HYDROGEOLOGICAL ASSESSMENT OF SANTOS QNT BEETALOO BASIN APPRAISAL PILOT – ENVIRONMENTAL MANAGEMENT PLAN.

PREPARED FOR | Environment Centre NT (ECNT)

PREPARED BY | Hydro Geo Enviro Pty Ltd

DATE | 19/12/2025

Figure 46 Cross-section B-B', with west–east orientation, across the Beetaloo GBA region, showing five potential hydrological connections for water or gas migration

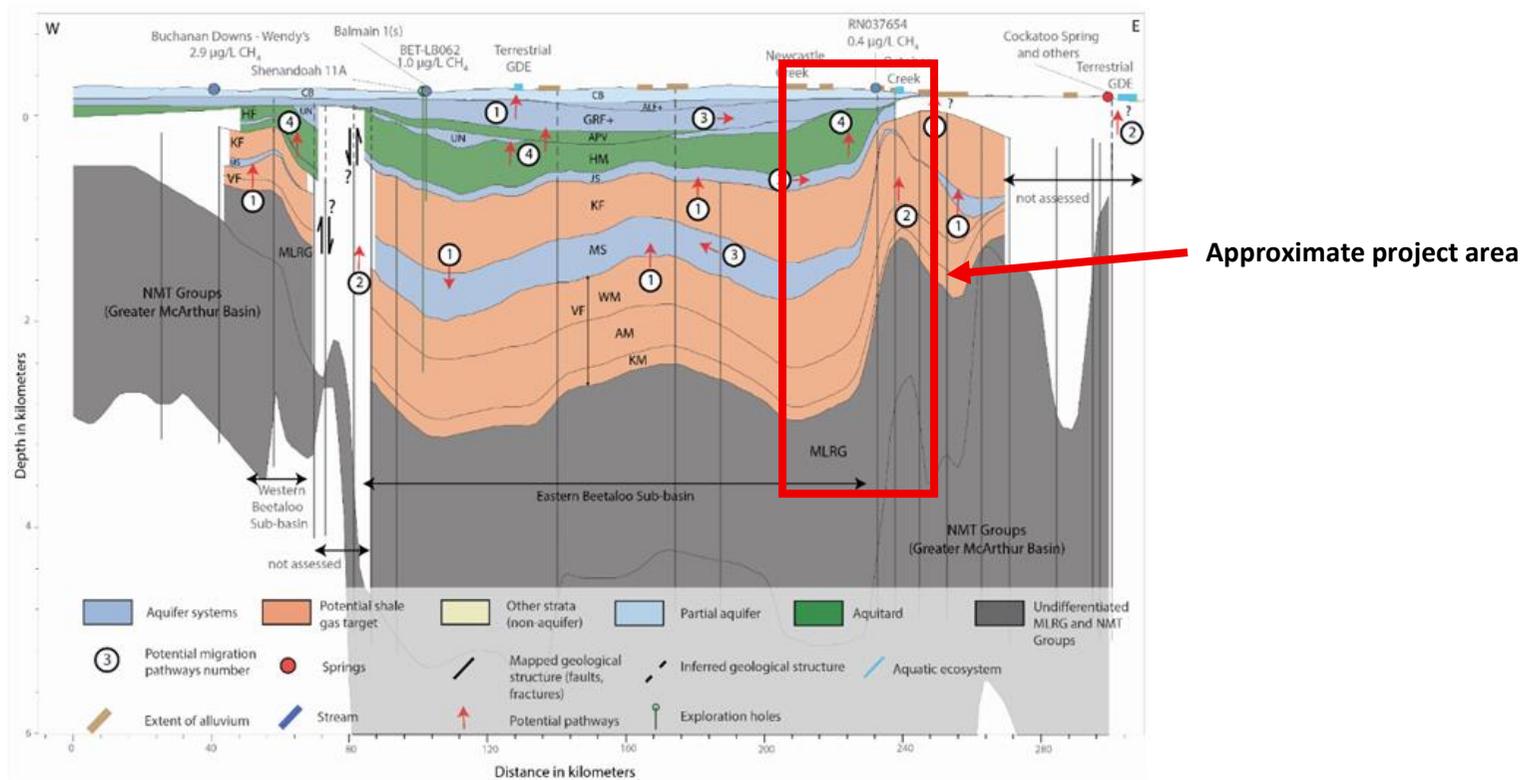
Page 66 – “After the production hole is drilled and logged, the production casing pipe is lowered to the total depth of the borehole (including horizontal laterals) and cemented in place (vertical pilot well total depth typically ten to 20 metres below the base of the lowermost hydrocarbon-bearing unit, but ideally not penetrating the underlying aquifer systems (if present)). The pilot hole will be isolated with cement. At both Jibera South and Newcastle south this is not anticipated, as the Velkerri formation (an interlaminated mudstone and siltstone) is anticipated to provide an impermeable layer between the lowest drill point and the potentially underlying Bessy Creek Sandstone partial aquifer.”

Comment – This impermeability between the Velkerri Formation and underlying Bessie Creek Sandstone needs to be demonstrated, not just anticipated. The Beetaloo Basin

Hydrogeological Assessment (Fulton & Knapton 2015 pg. 21) states that The Bessie Creek Sandstone outcrops on Tanumbirini and Carpentaria stations. The appraisal location is on Tanumbirini Station. Figure 11 in the EMP has The Bessie Creek Sandstone at 3500m below ground. The vertical separation can only be explained by faulting or major structural deformation of units. This needs to be better understood across the project, particularly to the east. Noting that the geological cross-section presented in Evans et al. (2020) do not contain information to the east of the project, see figure extracted below with approximate project area. Horizontal wells are planned to be up to 3.5km, this also needs be considered in the impact assessments.
